CITY OF ALBUQUERQUE

August 5, 2015

**RE: Santa Barbara Park Improvements
Grading and Drainage Plan
Engineers Stamp Date 7/16/15 (J15-D097)**

Re: Sigma Chi Parking Lot
1835 Lomas Blvd NE
Traffic Circulation Layout
Engineer's Stamp 08-02-16 (J15D098)

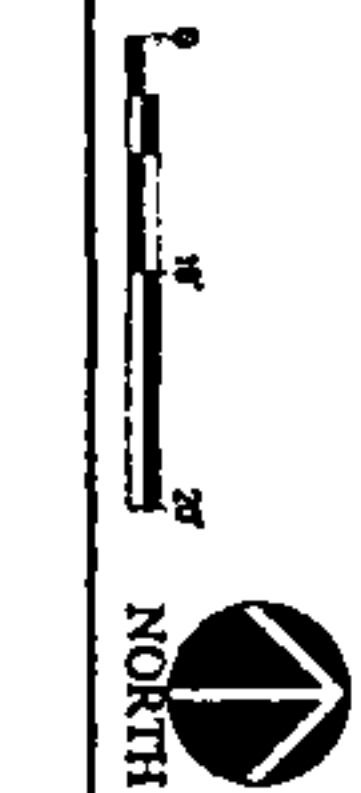
Please find attached a markup of our agreed upon drainage solution for the park improvements. We discussed the following:

- Addition of a containment curb along the north edge of the existing basketball courts to deflect the sheet flows out to Edith Blvd.
- The new playground will contain 100% of the storm waters generated in the playground limits
- Storm water flow will continue to discharge from the site as per the existing release characteristics

Fred,
Yes, this is as agreed. Sorry it took so long.
